#### ADDENDUM #2

## Will County Health Department BID PACKAGE #3 – MEP/Finishes/Carpentry/Glazing December 4, 2018

#### SECTION 00 91 08 BP #3 - ADDENDUM NUMBER 2

PROJECT: WILL COUNTY HEALTH DEPARTMENT - NEW HEALTH DEPARTMENT

> **OVERALL SITE UTILITIES PLAN**

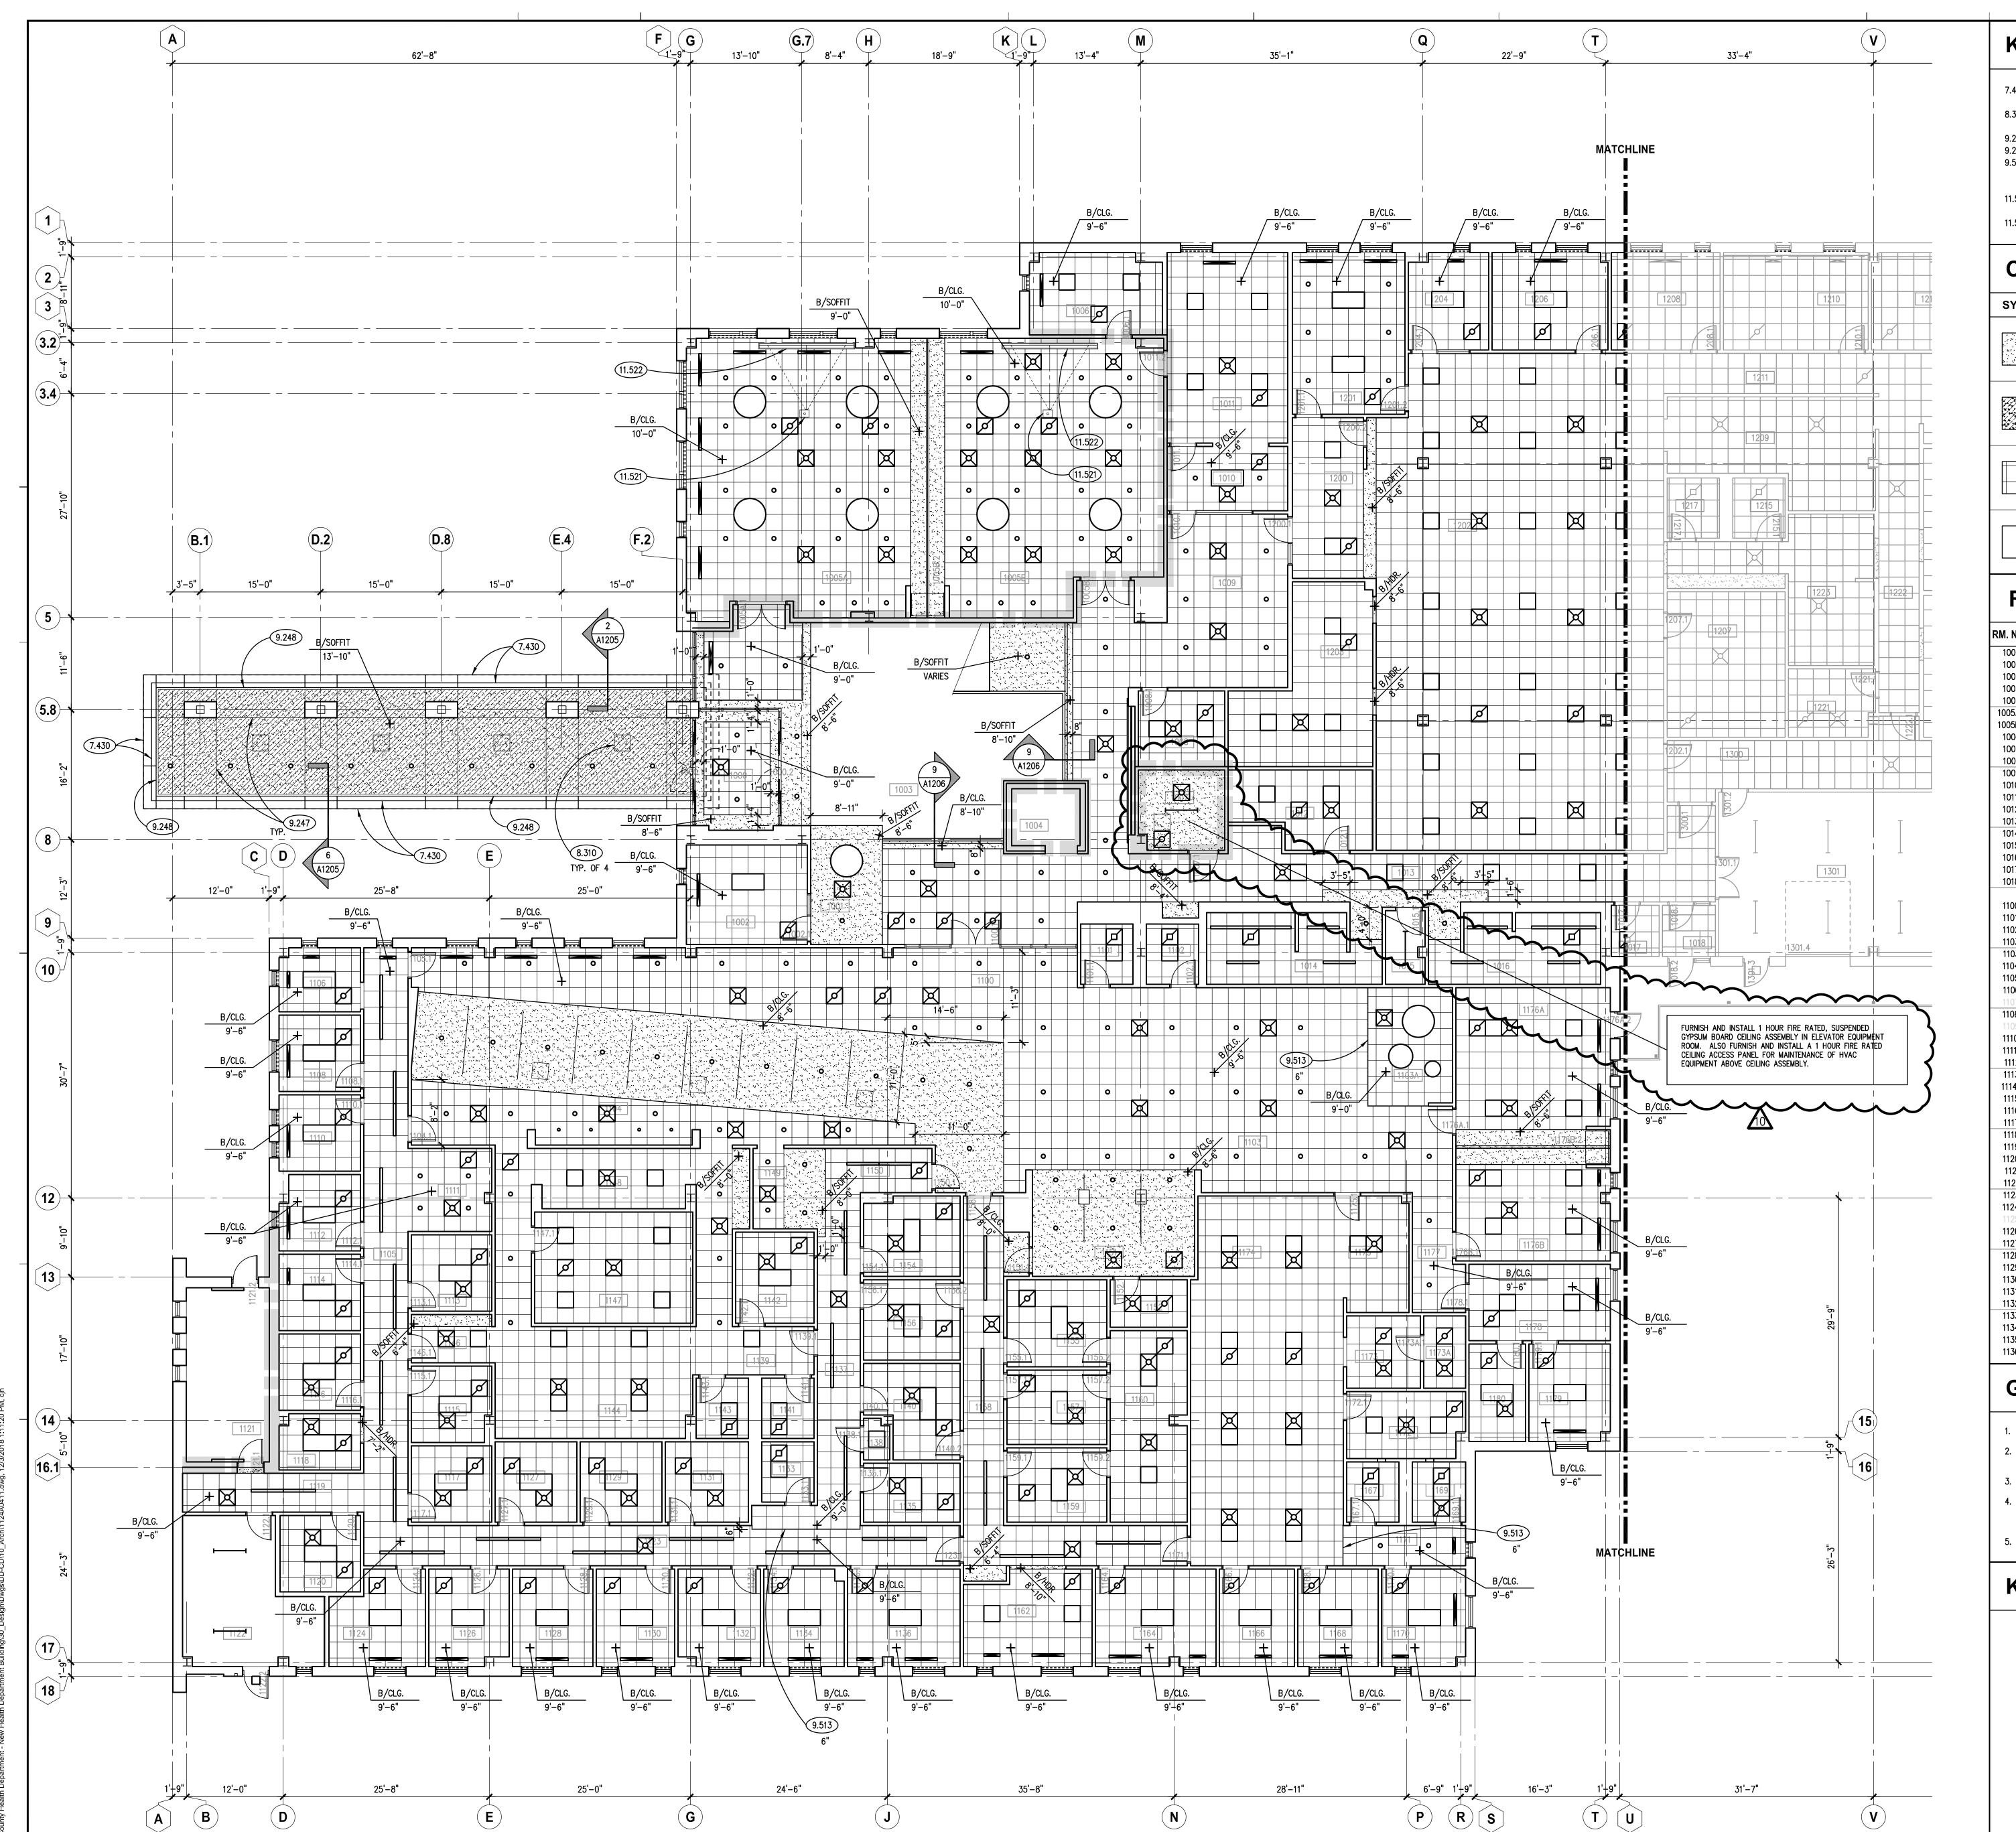
A. (For contractor clarification only): Clarified and corrected written text at the right hand side of the page that was corrupted during printing of Bid Package #3 for reference. See revision cloud 10.

PARTIAL FIRST FLOOR REFLECTED CEILING PLAN - AREA 'A' (1)

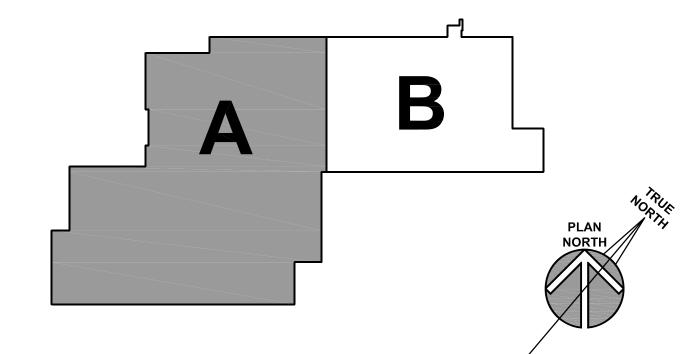
A. Revised Detail 1/A411 to indicate a 1 hour fire rated drywall ceiling assembly and 1 hour fire rated access panel in the elevator machine room as shown.

**EAST ELEVATION**

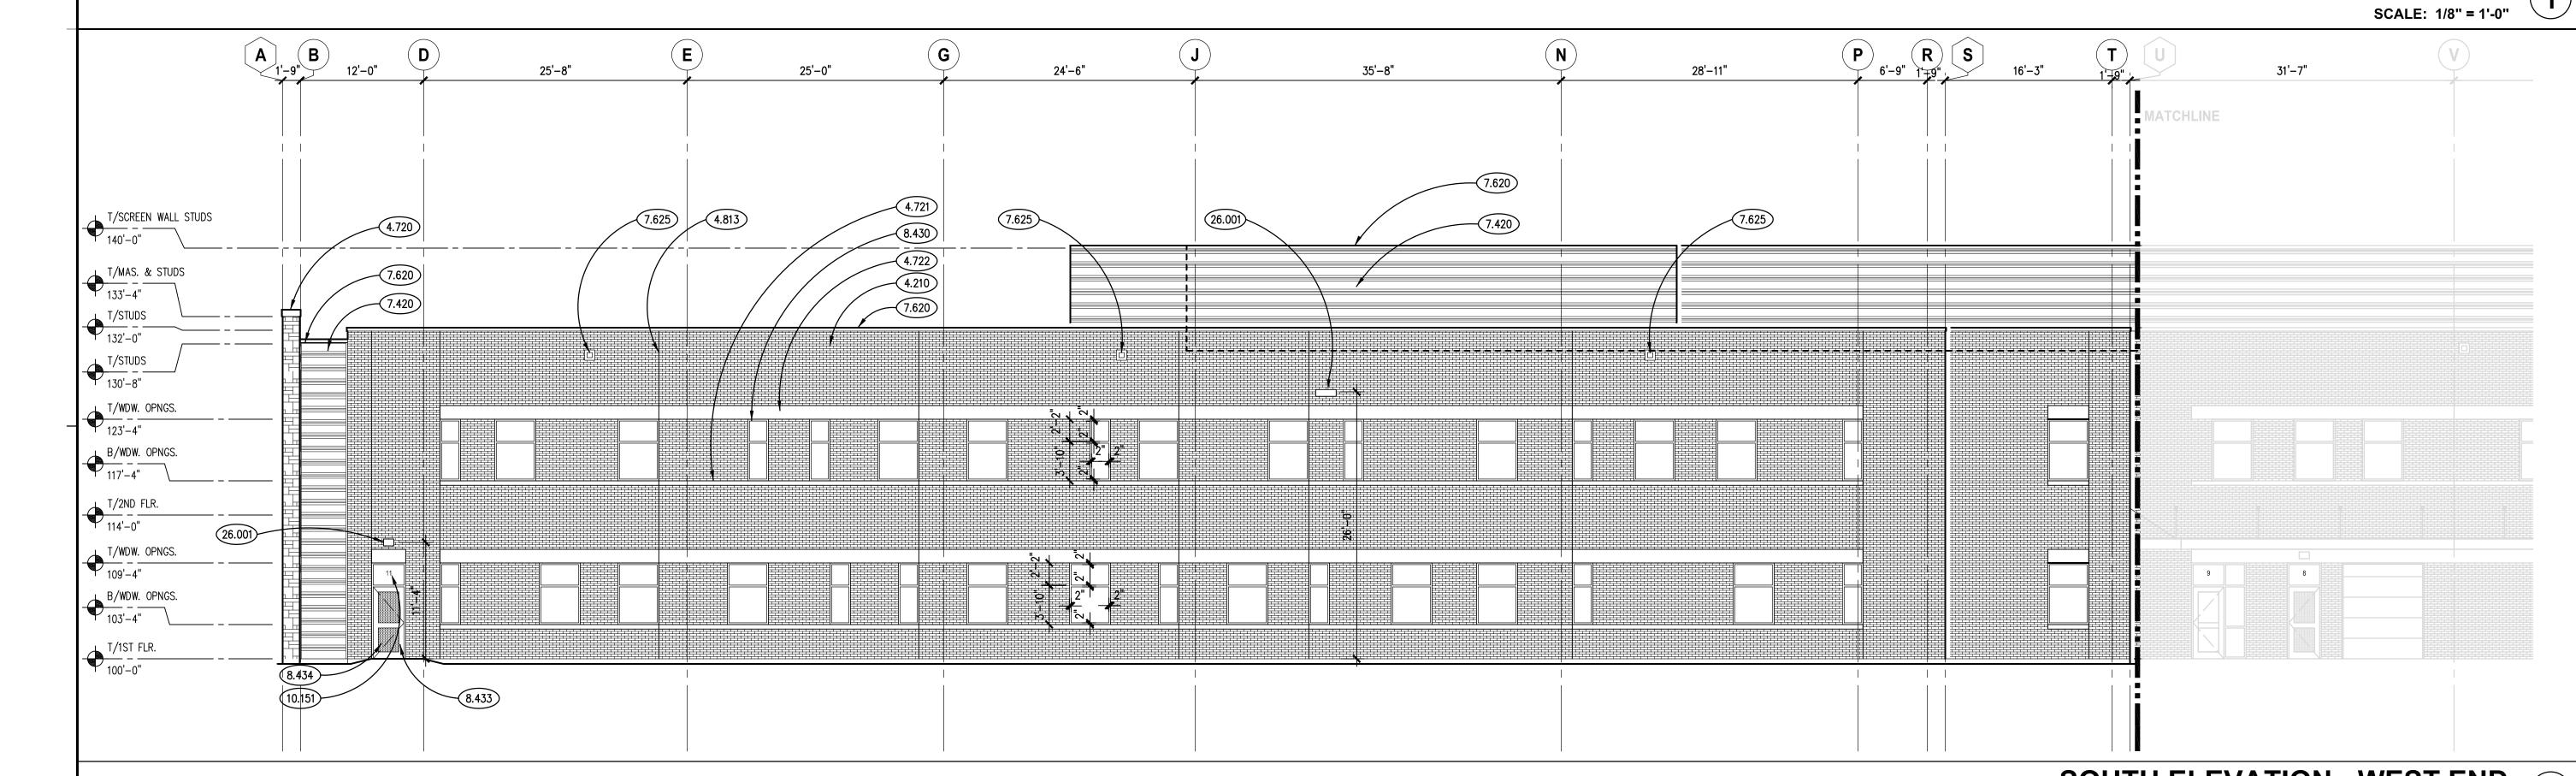
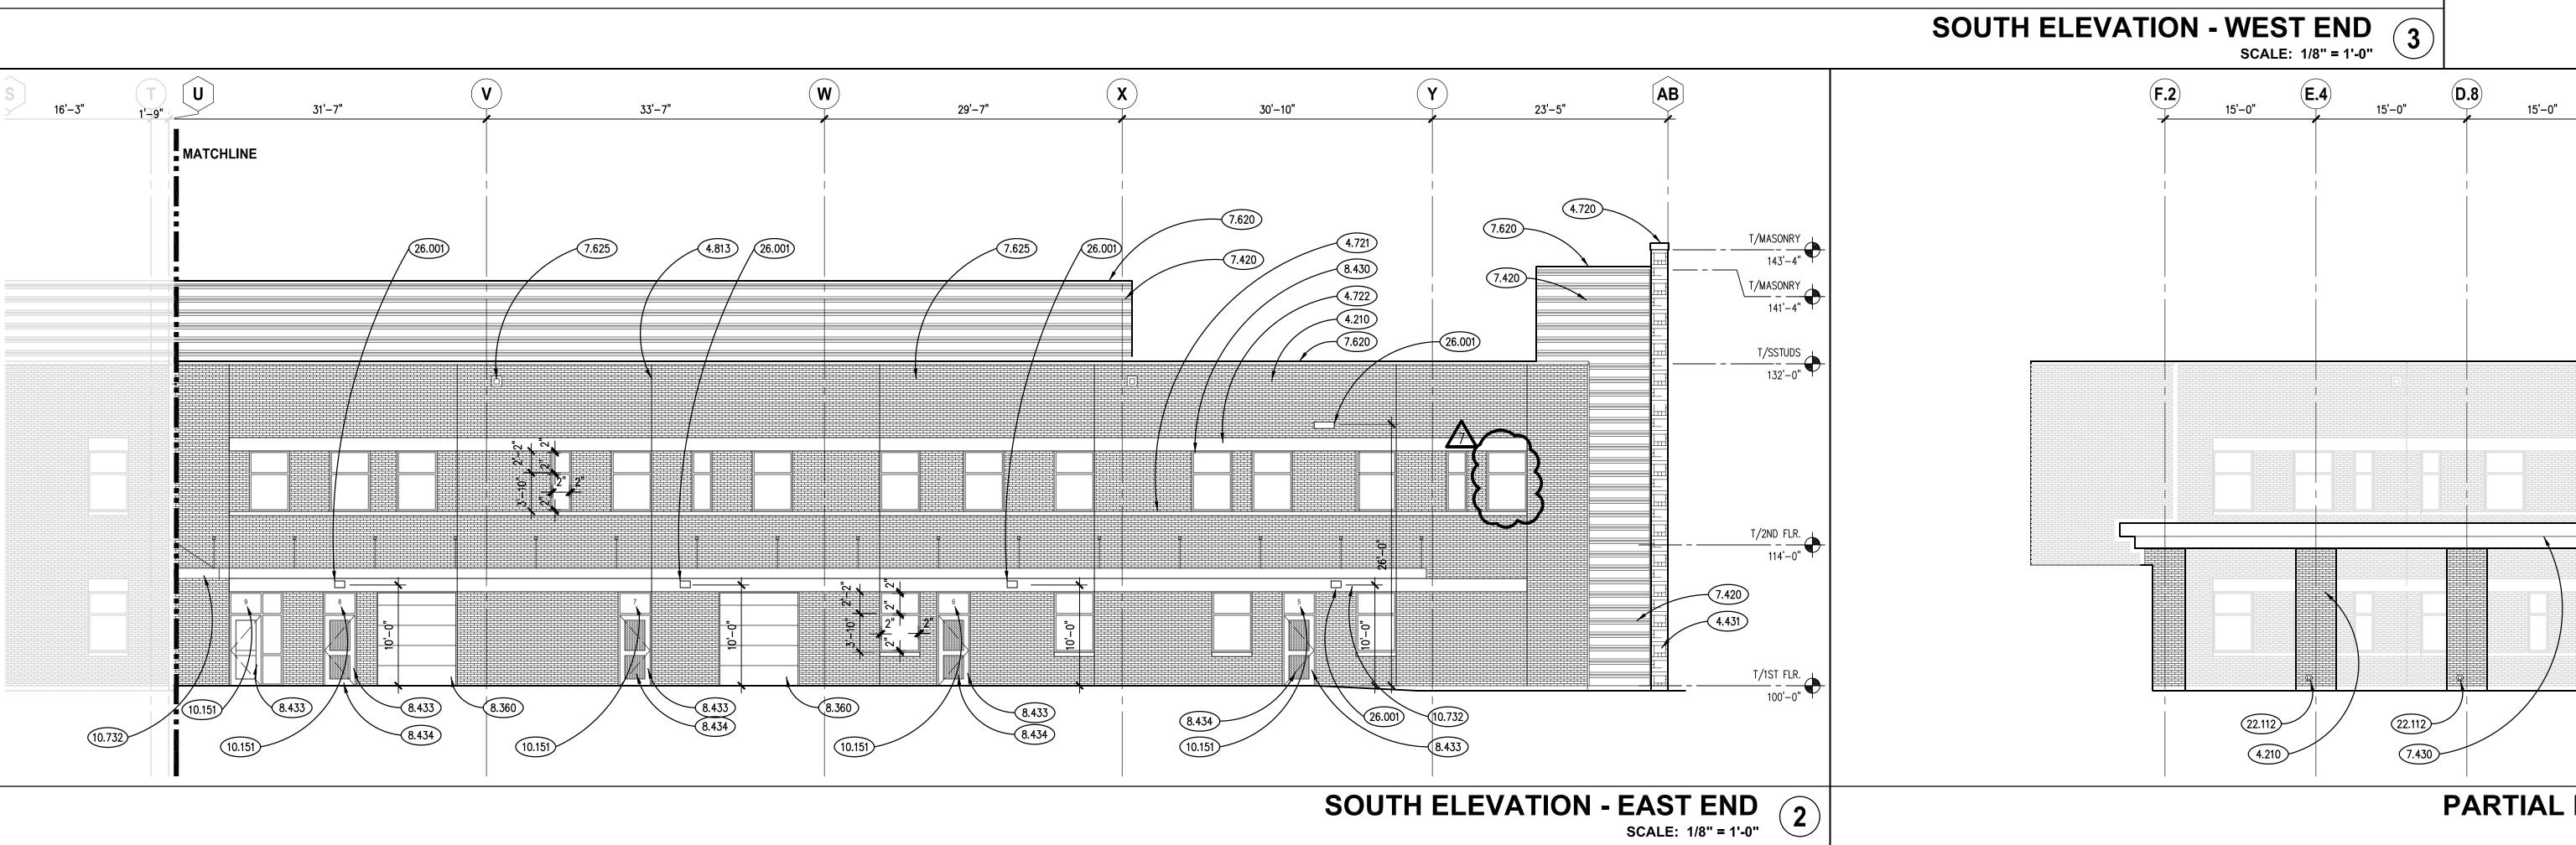
A. Clarified Detail 1 - East Elevation top of masonry wall height adjacent to Reference Line 1.
